NAFLIC - Standards & Related Documents Committee | TECHNICAL BULLETIN

485. Moser's Rides tower ride/spring ride

This bulletin concerns the threaded connection between the ram and the pulley frame on Moser's Rides' spring and tower rides.

SPRING RIDE SERVICE BULLETIN 1-2017

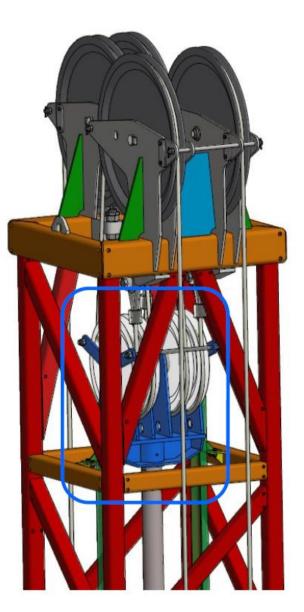
During an annual inspection a UK registered inspection body identified damage to the threads on the ram rod of the double acting cylinder. The condition of the ram, and the pulley frame to which it connects, can be seen in the photographs below.

The connection is a single point failure, the unfastening or failure of which could result in the passengercarrying bench falling onto the dampers (possibly from a considerable height).

It should also be noted that whilst we are passing both bulletins on for information this is not to say that the Standards Committee endorses either of them. We do, however, wish to ensure that all relevant parties are aware of the problem and we urge all controllers and inspection bodies to ensure that due attention is paid to these areas during daily, weekly and monthly checks as well as during annual inspections.

Cylinder Shaft- Pulleys Support Tightening Con-

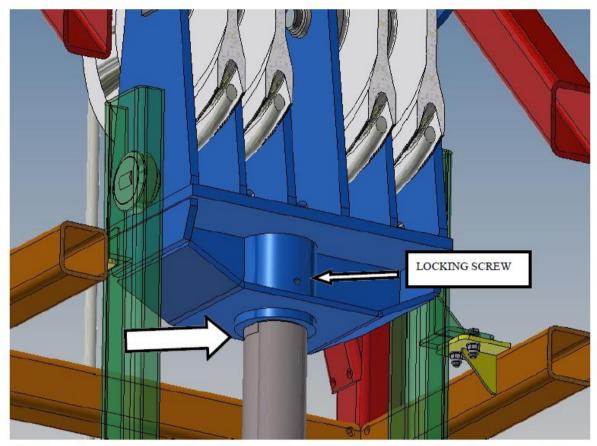
VISUALLY CHECK EVERY 2 WEEKS THE TIGHTENING OF THE CYLINDER SHAFT AND PULLEY BLOCK. THEY MUST BE PRO-PERLY CONNECTED. MARKING A VISUAL REFERENCE AMONG THE 2 PARTS MIGHT HELP TO DETECT ANY UNSCREWING.

THE PULLEY BLOCK MUST BE COMPLETELY PLUGGED INTO THE CYLINDER SHAFT. IF NOT IT MUST BE TIGHTEN BACK INTO POSITION:

- A) REMOVE THE LOOKING SCREW.
- B) BY A LARGE WRENCH KEY LOCK THE SHAFT BY THE 2 FLAT TABS AND TIGHT IT ANTICLOCKWISE ALL THE WAY TO THE LIMT
- C) RESTORE THE LOCKING SCREW

VISUALLY CHECK EVERY 2 YEARS (APPLICABLE ONLY FOR UNITS THAT HAVE BEEN OPERATING FOR 5 YEARS UNLESS THE FACTORY ACCUMULATOR SETTINGS HAVE BEEN ALTERATED: 50 BAR AND THE REVERSE THRUST OF 2,5 G) THE CYLINDER SHAFT AND PULLEY BLOCK THREADS BY CHEKING THE INTEGRITY OF THE THREADS.

IF BY VISUAL CONTROL ONE OR BOTH OF THE TWO THREADS IS WORN OR DAMAGED, THE CYLINDER SHAFT AND THE PULLEY BLOCK SHALL BE REPLACED WITH NEW UNITS.

THE INDIVIDUAL DAMAGE OF ONLY ONE OF THE TWO ITEMS REQUIRES A FULL REPLACEMENT OF BOTH THE SHAFT AND PULLEY PACK.
